### **REMARKS/ARGUMENTS**

This Amendment is responsive to the Office action dated February 25, 2004, setting forth a shortened three month statutory period for reply expiring on May 25, 2004.

Circuit and Method for Discharging High Voltage Signals

ANNOTATED SHEET SHOWING CHANGES

FIG. 1

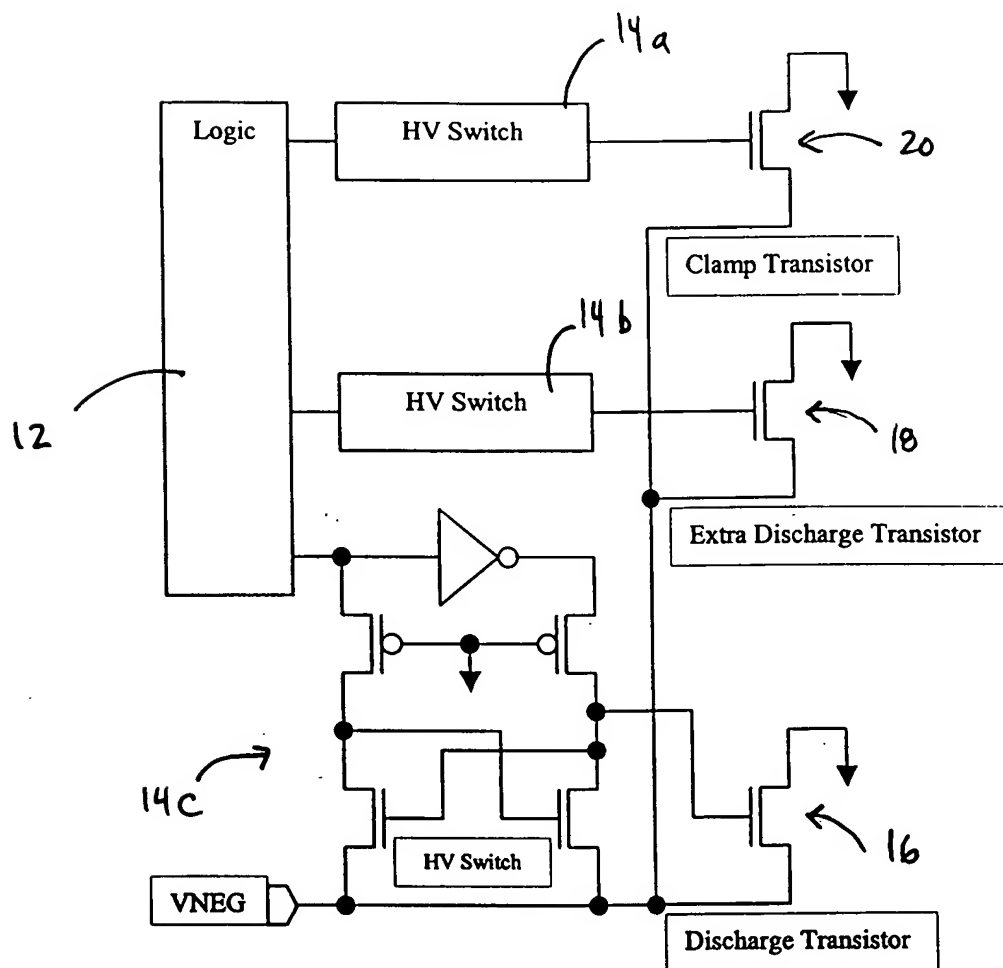
The Examiner indicated his belief that "Fig. 1 should be designed by a legend such as "Prior Art" and requires a proposed drawing correction. Accordingly, Fig. 1 has been amended to include the legend "PRIOR ART" and it is respectfully requested that this objection be withdrawn.

LEGEND  
"PRIOR ART"  
ADDED
